HWY. No. 401LOCATION Fountain St. Watermain / Hwy 401 Crossing, City of CambridgeNo of PAGES -

RE: Fountain St. Watermain
Region of Waterloo
Highway 401 Crossing

RE: Fountain Street Watermain
Highway 401 Crossing

Re: **Fountain Street Trunk Watermain**
Highway 401 Crossing
Cambridge, Ontario

BOREHOLE: 308

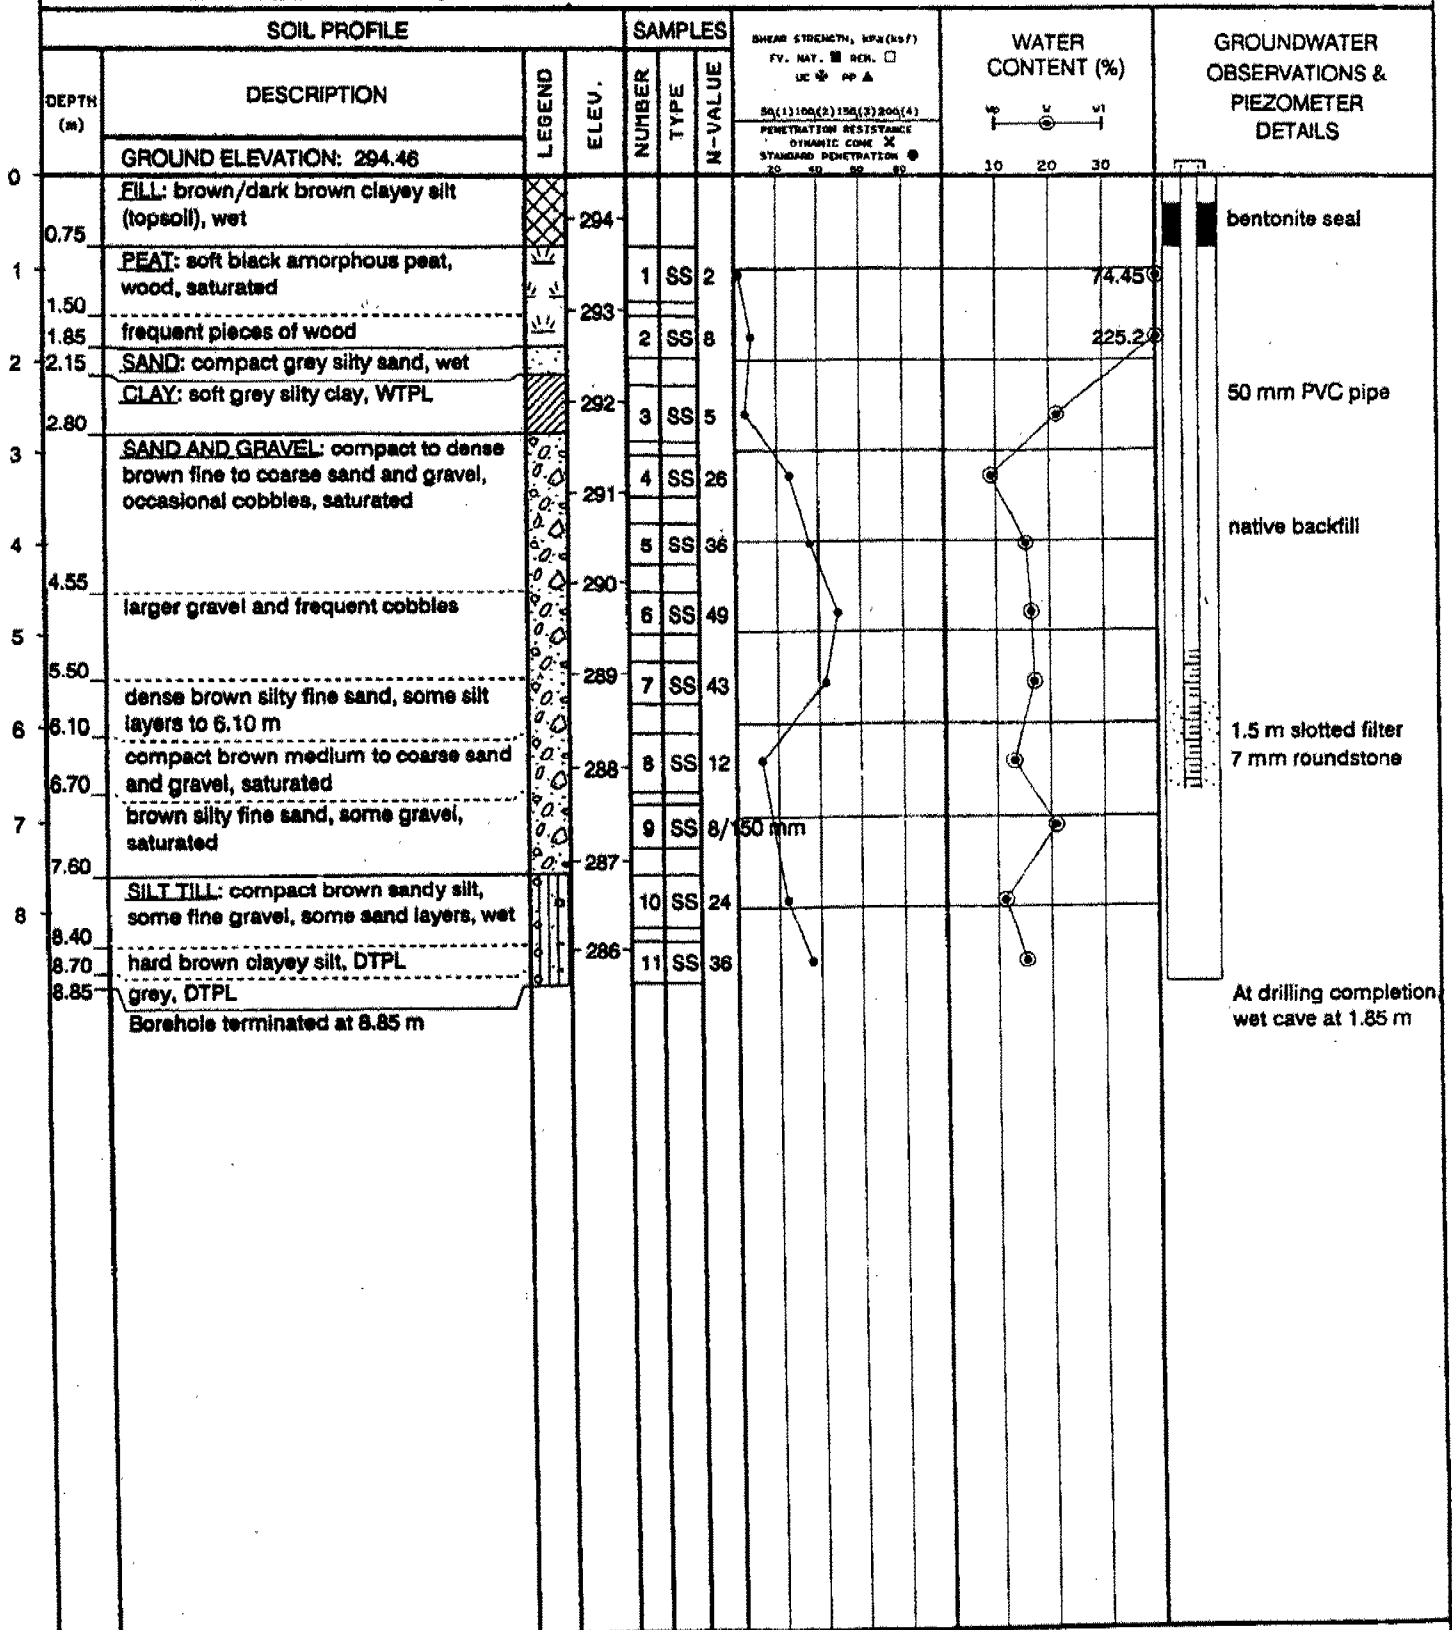
<u>BH. No.</u>	<u>Original G.W.L.</u>	<u>G.W.L. After Pumping</u>
304	El. 293.2	El. 292.3
301	El. 292.6	El. 290.8
308	El. 294.1	El. 293.3

With the exception of BH. 301, the groundwater was not lowered to the invert level, therefore, the effect of the drawdown on the structure foundation can not be determined.
